Product change

EPCOS CeraLink capacitors up to +150 °C operating temperature

170303CER1e

Product / Process Change Notification

Examples of new and previous marking

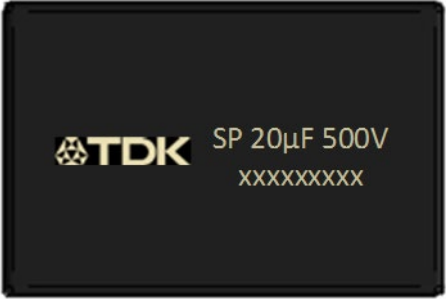
After the successful production start of the affected CeraLink capacitors, we will skip the marking of every single component with the batch number.

New		Previous	
LP L-lead	LP J-lead	LP L-lead	LP J-lead

SP		SP
